MEMORANDUM FOR: the Record:

Ref the attached [ ] letter (1058/PLI-82), dated 23 July 1965.

Enclosed herewith is the revised industrial design concept for the High Resolution Step and Repeat Contact Printer, which has been revised in accordance with the changes requested by your Technical Monitor. Please forward this immediately to

ENCLOSURE TO   
LETTER 1058/PLI-82,  
DATED 23 JULY 1965.

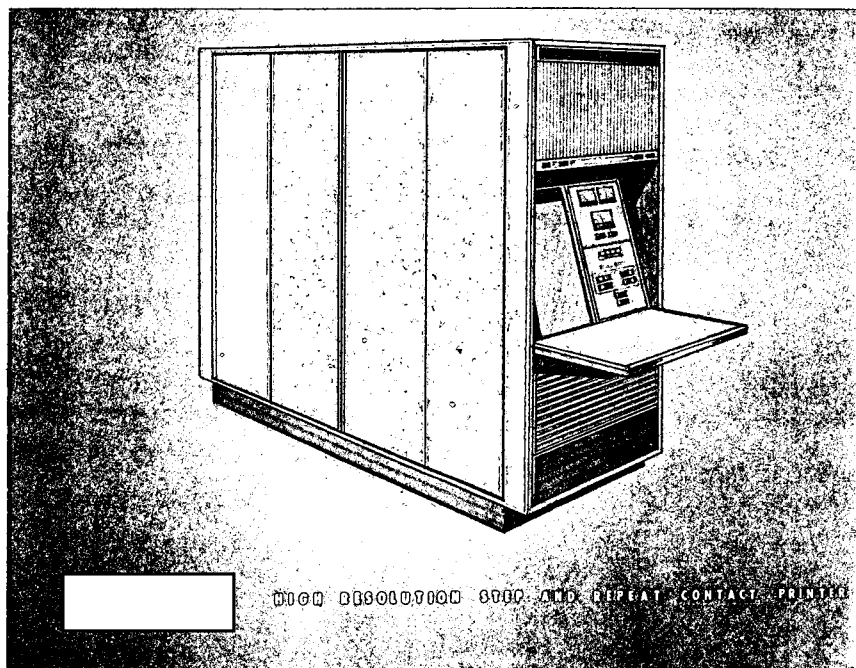
The changes mentioned in the reference were initiated by [ ] and were first presented to us at a meeting here on 30 June 1965. Present were [ ]

[ ] PSD/PLB, and self, DB/P&DS. Jack D. agreed to the new, end-viewing, design so I told [ ] to go ahead. The change was not made at our request.
